**ADDENDUM TO THE
LOS ANGELES AERIAL RAPID TRANSIT PROJECT
ENVIRONMENTAL IMPACT REPORT
LOS ANGELES, CALIFORNIA**

October 2026

State Clearinghouse No. 2020100007

Figure 4-3, Los Angeles Aerial Rapid Transit Project Area.

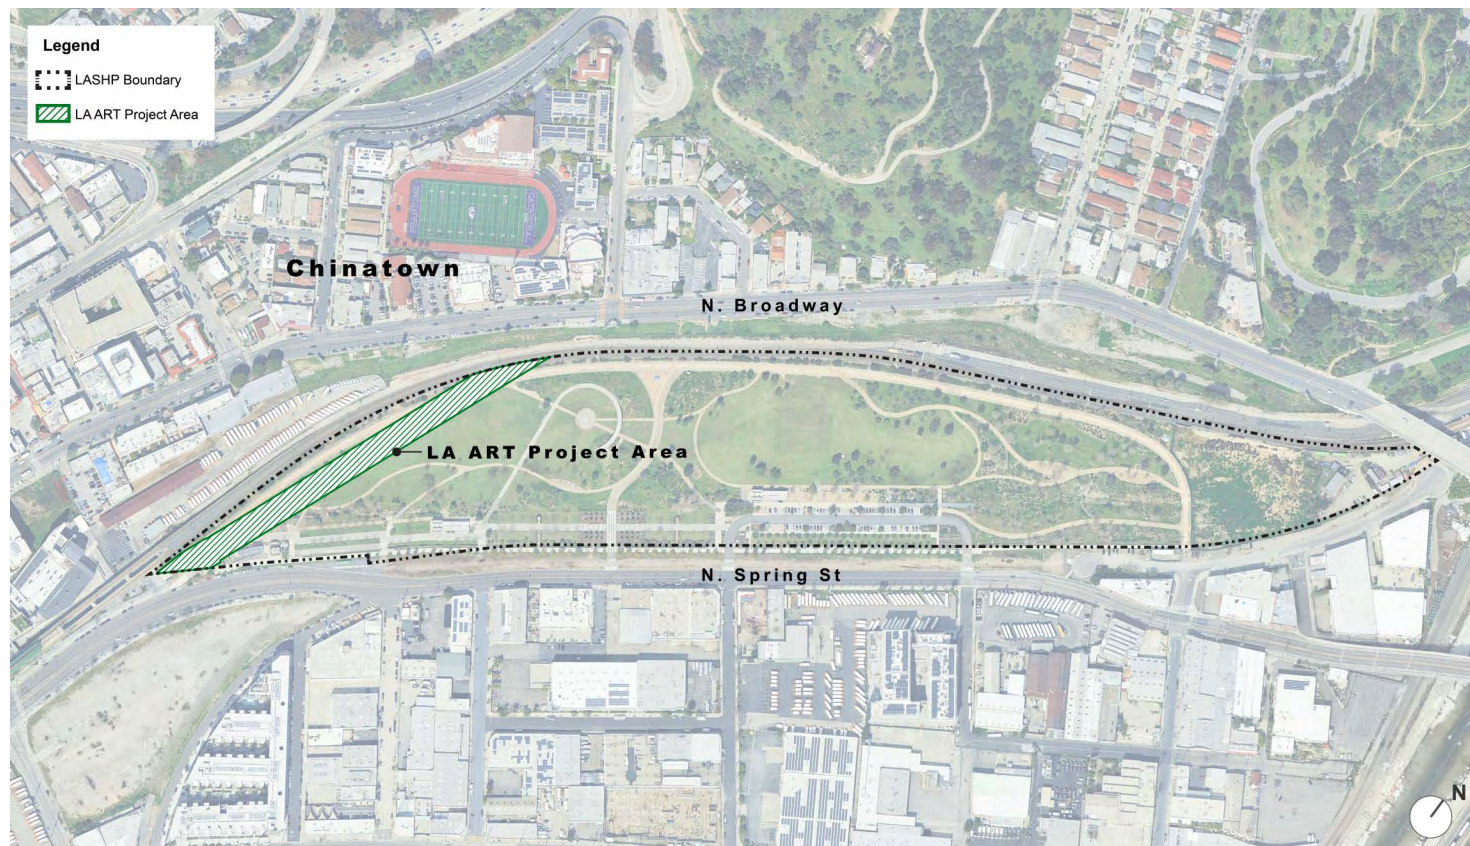
- **Addition 2, LA ART Project Area (Illustration):** An illustration of the LA ART Project Area within LASHP is added as Figure 4-3, Los Angeles Aerial Rapid Transit Project Area. This proposed addition is made to Chapter 4.4 of the General Plan, Preferred Park Concept, and is intended to appear on page 75, under Preferred Park Concept Elements.

The Los Angeles Aerial Rapid Transit Project Area (LA ART Project Area), as illustrated in Figure 4-3, will accommodate the portion of the Los Angeles Aerial Rapid Transit Project (LA ART Project) located in the Park. The LA ART Project is a 1.2-mile aerial gondola public transit system intended to connect Los Angeles Union Station to Dodger Stadium. The proposed LA ART Project would include an intermediate public transit station at the southernmost entrance of the Park.
